Service Note		
Product	Description:	Service note no.
Remote CPU	Old Flash RAM card does not work with newest software	SNo-T0151

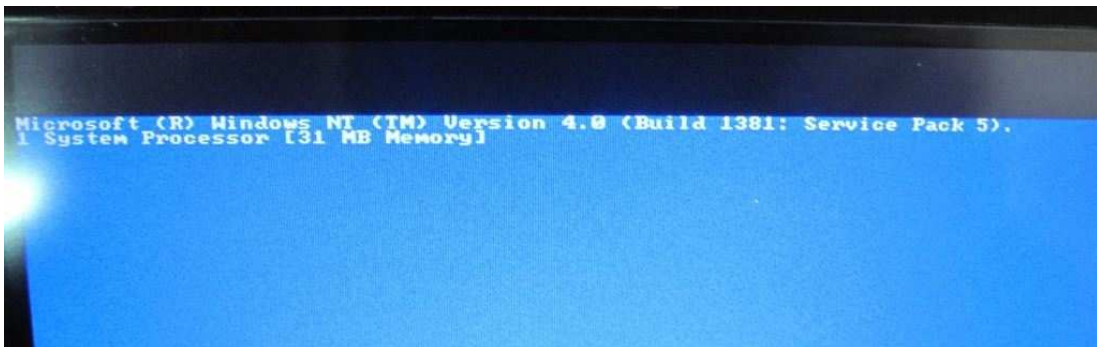
A Remote-CPU with "old" Flash RAM-card (32MB) cannot contain the newest application software (5.04 or newer) needed to work with the System6000MKII frame.

The type of Flash RAM-card in the Remote-CPU can be seen during boot.

Turn on the Remote-CPU, on the ICON screen you can see the Flash RAM-card version (see attached picture)

This is easily fixed by replacing the Flash RAM-card to the new type: 712016701
